northern beaches council
PLANS APPROVED BY THE LAND AND ENVIRONMENT COURT OF NSW
PROCEEDINGS NO: 2023/238892
DATED: 5 June 2024

FOR S4.55 (8) APPLICATION

PROJECT:
PROPOSED SENIORS LIVING
4 ALEXANDER ST, COLLAROY
NSW

BOUNDARY CONDITION STUDY

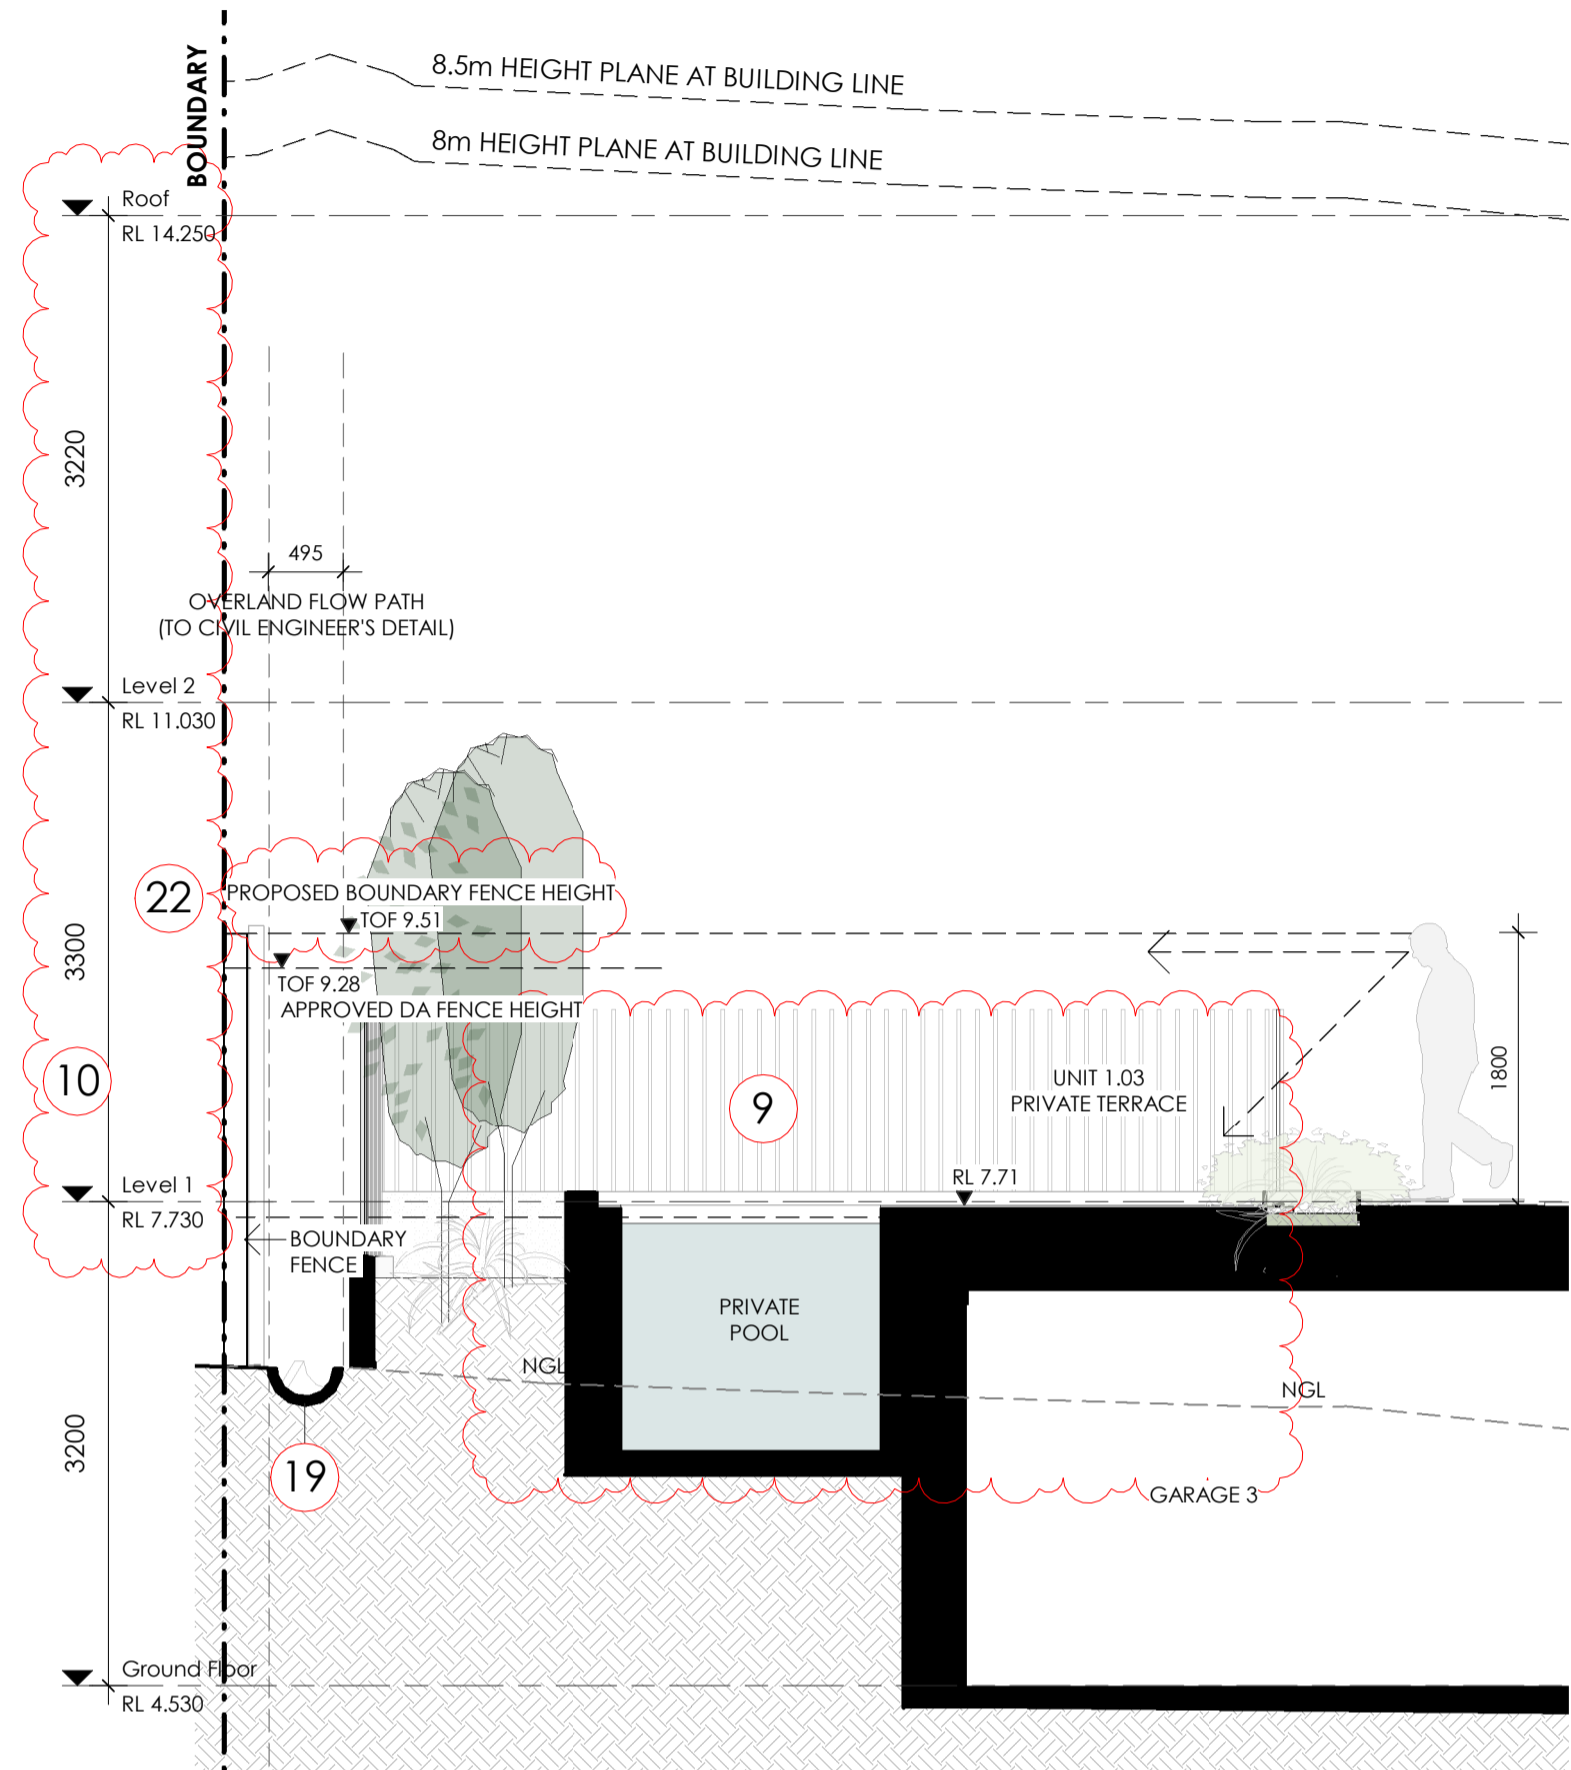
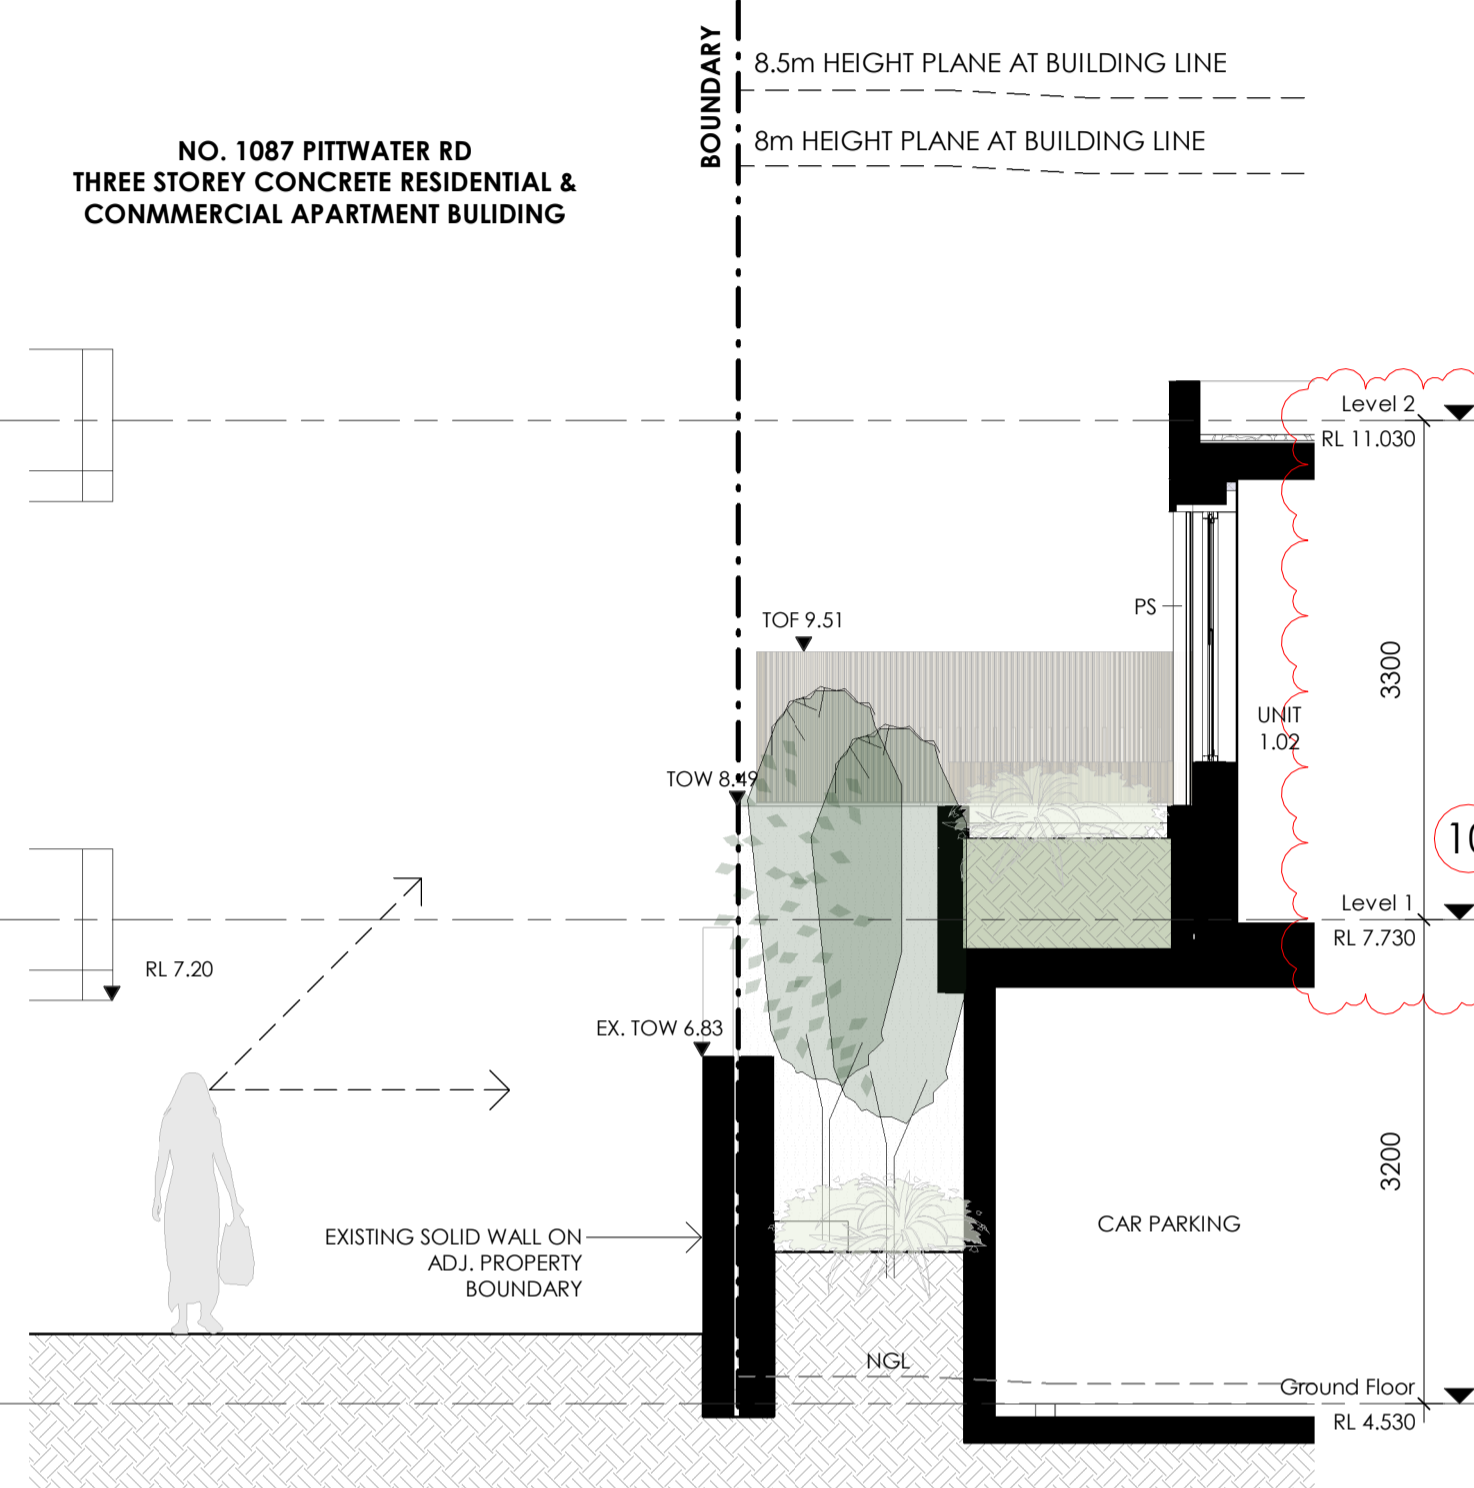
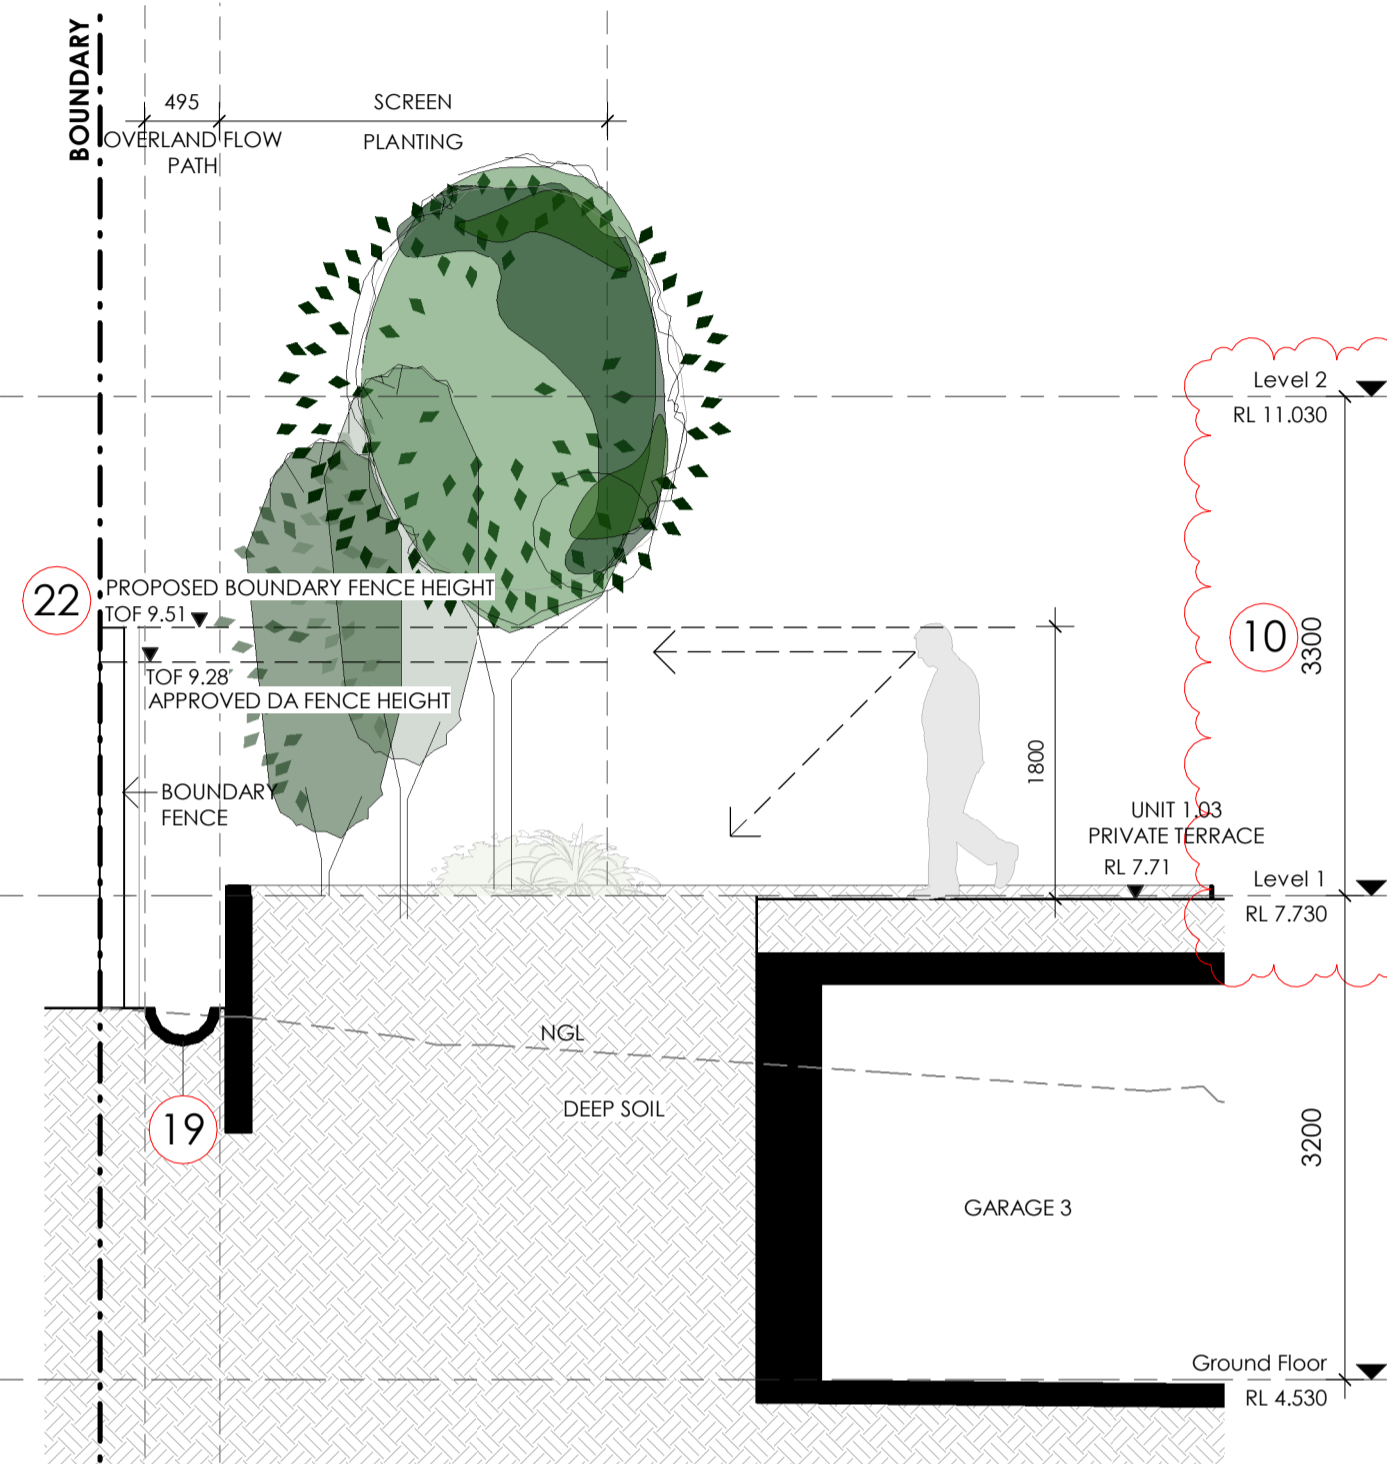
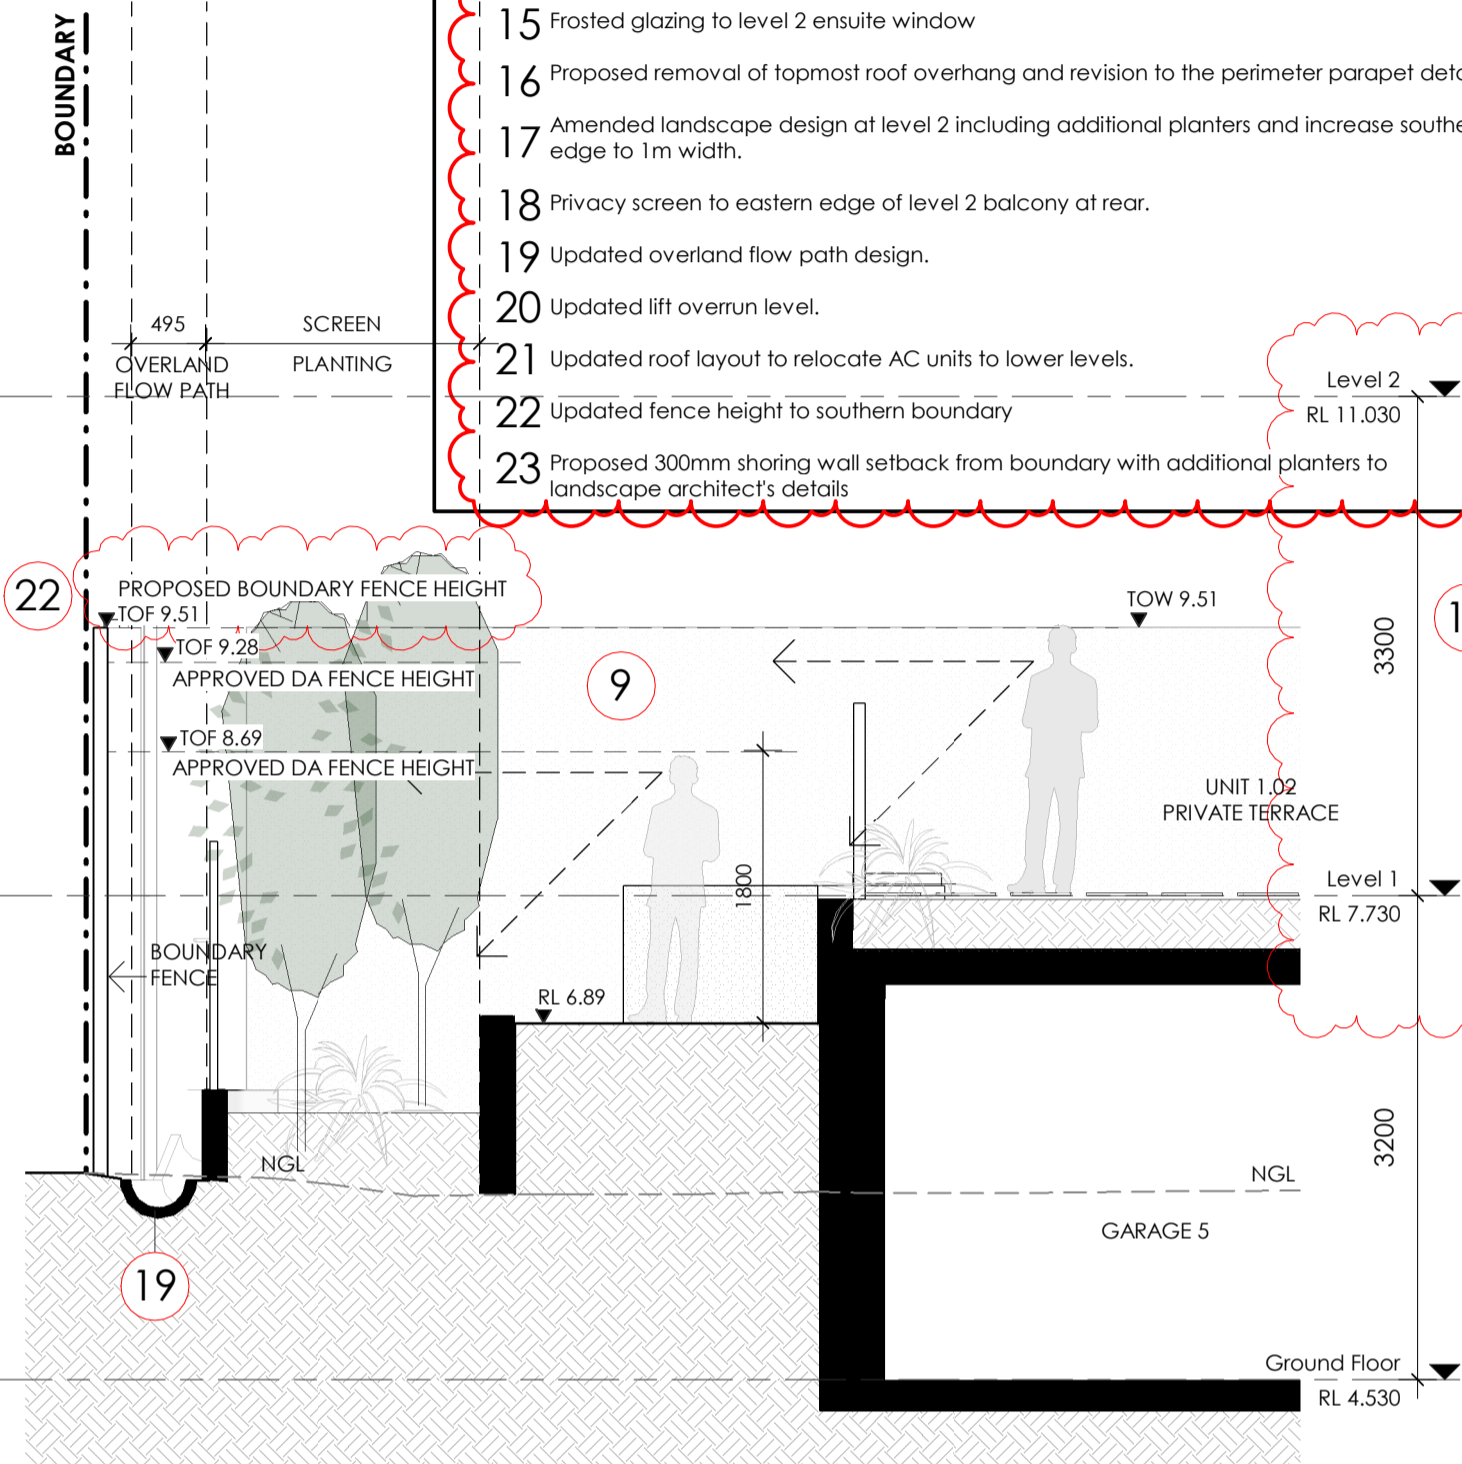
- Proposed modifications to skylights including deletion of 2 skylights over unit 2.01, and updated sizes of skylights over Unit 1.02 & 1.03.
- Additional storage room at basement level.

- Updated interior layout generally.
- Modification to facade windows openings and configurations generally.
- Additional metal framed louvre awning to Level 2.

- Proposed removal of flood gate from driveway and associated DA Condition 28.
- Proposed external design modifications including additional BBQ benches, planters, fences and gates for maintenance access to side planters at rear (Level 1).

- Updated stormwater concept design.
- Associated landscape design update including:
 - a) Level 1: proposed updated overland flow path based on civil eng.'s assessment

- b) Level 1: proposed 2 additional private plunge pools at rear
 - c) Level 1: Revised boundary fencing height and design at rear
 - d) Level 1: Revised external levels

- e) Level 1: Revised external backyard
 - f) Ground floor: Revised front garden design to G.01 and around OSD tank area
- Proposed building height increase including adjustments to floor levels to:

- Level 1: RL 7.73
 - Level 2: RL 11.03
 - Roof: RL 14.25
- Updated roof layout including adjustment to lift overrun structure, services layout and photovoltaic panels. Proposed deletion of DA Condition 8 as part of the proposed amendments at roof level.

- Updated extent of shoring and retention generally.
- Modification to proposed car parking arrangement and number of car space.
- Adjustment to level 2 envelope shifting towards west generally.

- Frosted glazing to level 2 ensuite window
- Proposed removal of topmost roof overhang and revision to the perimeter parapet detail.
- Amended landscape design at level 2 including additional planters and increase southern edge to 1m width.

- Privacy screen to eastern edge of level 2 balcony at rear.
- Updated overland flow path design.
- Updated lift overrun level.
- Updated roof layout to relocate AC units to lower levels.

- Updated fence height to southern boundary
- Proposed 300mm shoring wall setback from boundary with additional planters to landscape architect's details
